**IN THE MATTER** Notices of Requirement to  
enable the construction,  
operation and maintenance of  
the City Rail Link

**EVIDENCE OF DR JOHN HERBERT HEILIG  
ON BEHALF OF MEDIAWORKS NZ LIMITED (IN RECEIVERSHIP)  
AND TVWORKS LIMITED (IN RECEIVERSHIP)**

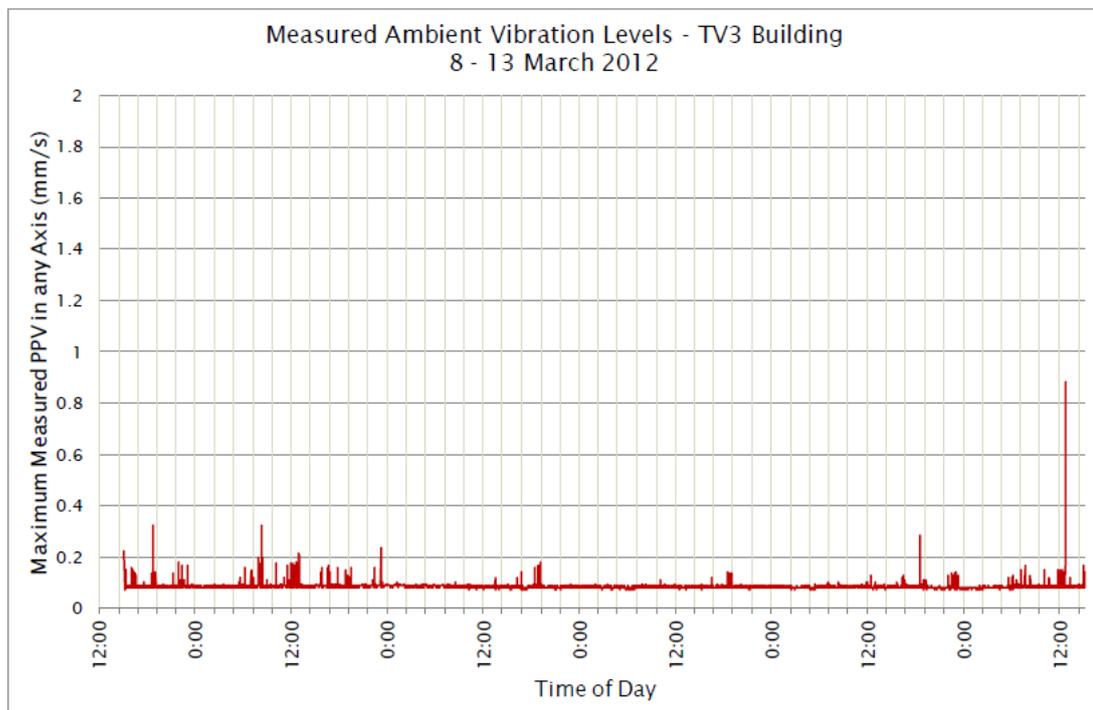
- 54.** Mr. Whitlock has developed a series of construction contour maps showing where vibration criteria may be exceeded. These have been revised since the initial report, although it is unclear to me as why the revision was undertaken given the equipment used to develop the tunnel has not changed. The impact of the construction activities is referenced to the German Standard DIN4150 of 5mm/s which is appropriate for long term impulsive vibration, but inappropriate for continuous vibration. Impulsive vibration corresponds to vibration induced by activities such as blasting and occurs for a period generally not longer than a few seconds. Long term impulsive vibration corresponds to impulsive vibration that occurs many times during the construction period (ie, blasting every day over a six month period), although with each event only lasting for a few seconds. Continuous vibration differs from long term impulsive vibration in that the duration of an event is extended, with continuous vibration persisting often for tens of minutes rather than a few seconds. Whilst it may be appropriate to assess blasting induced impulsive vibration against the German DIN4150 Standard, it is inappropriate to assess those activities that produce continuous vibration, such as a TBM, hydraulic hammer, road header or other equipment indicated as being likely construction equipment by Mr. News, against the same German Standard. Mr. Whitlock has interchanged criteria appropriate for long term vibration versus continuous vibration on the basis of fatigue rather than amenity which is the commonly applied performance assessment parameter for continuous vibration. The contour map for the area about the TV3 studio is provided in Appendix H of the MDA technical report and is partially reproduced in the figure below:

55. I accept the method of showing vibration contours is a useful technique for identifying potentially affected properties, however I note in Mr. Whitlock's analyses that the level of vibration at the corner of the TV3 building where the studios are located is likely to exceed 1mm/s (ie: 10 times the level that produces regenerated noise) with more than 2/3 of the building receiving vibration above 2.5mm/s (green contour) (ie: 25 times the level that produces regenerated noise). It is also unclear as to why the vibration contours are of the shape shown in the drawing shown in the MDA report. I would have expected that the contours would continue about the alignment of the tunnel rather than cease at allocation through the MediaWorks building. I am also unsure as to the source of the vibration and whether this vibration relates to a TBM or other method of construction, particularly given the ambiguity about the method of construction. Equally important, the predicted levels of vibration do not take into account the construction of the MediaWorks building which is detailed in the evidence of Mr. Simpson and Mr. Vaughan. The piered construction method is likely to affect the accuracy of the vibration prediction, particularly given that the piles on which the

building in the area of the broadcast studio are founded extend deeper into the material between the building and the tunnel, effectively reducing the length of the transmission path for the vibration between the building and very likely increasing the level of vibration receiving from any tunnelling activities.
